## STAFF REVIEW AND RECOMMENDATIONS PUBLIC HEARING DECEMBER 1, 2021

ABBREVIATED PLAT:	STONERIDGE HEIGHTS 2021		
LEGAL DESCRIPTION:	SEC 26, T18N, R01W, SEWARD MERID	IAN AK	
PETITIONERS:	G & A PANONCILLO FAMILY TRUST		
SURVEYOR/ENGINEER:	KEYSTONE SURVEYING/PIONEER ENGINEERING, LLC		
ACRES: 2 <u>+</u>	PARCELS: 2		
<b>REVIEWED BY:</b>	AMY OTTO-BUCHANAN	CASE #: 2021-178

## STAFF REVIEW AND RECOMMENDATIONS PUBLIC HEARING DECEMBER 1, 2021

ABBREVIATED PLAT:	BLUEBERRY POND		
LEGAL DESCRIPTION:	SECs 29/30, T25N, R04W, SEWARD MERIDIAN AK		
PETITIONERS:	R. JOHN STRASENBURGH & RUTH D. WOOD		
SURVEYOR:	BULL MOOSE SURVEYING		
ACRES: 117.3 <u>+</u>	PARCELS: 1		
<b>REVIEWED BY:</b>	AMY OTTO-BUCHANAN	CASE #: 2021-181

Project Stoneridge Heights Lt4 Blk2

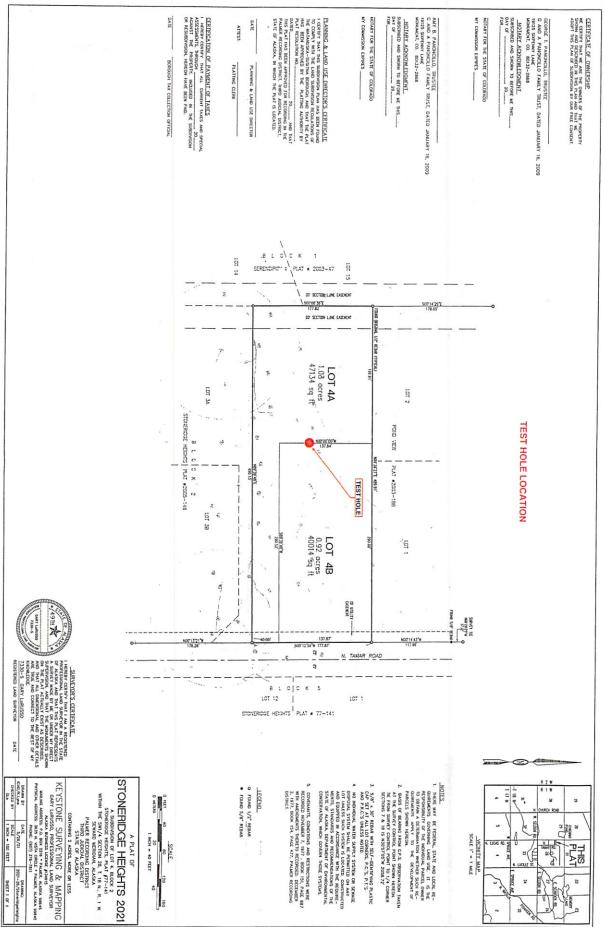
<u>Comments</u>: Department of Public Works (Exhibit C) notes the gradation of the silty material was not included in the soils report. *Staff notes it was supplied by the engineer and is included in the Soils Report.* DPW has no further comments. Planning Division (Exhibit D) has no objections.

The soils report refers to a gradation of the GM or SM soils but I couldn't find one in the file.

I received the gradation. I have no further comments.
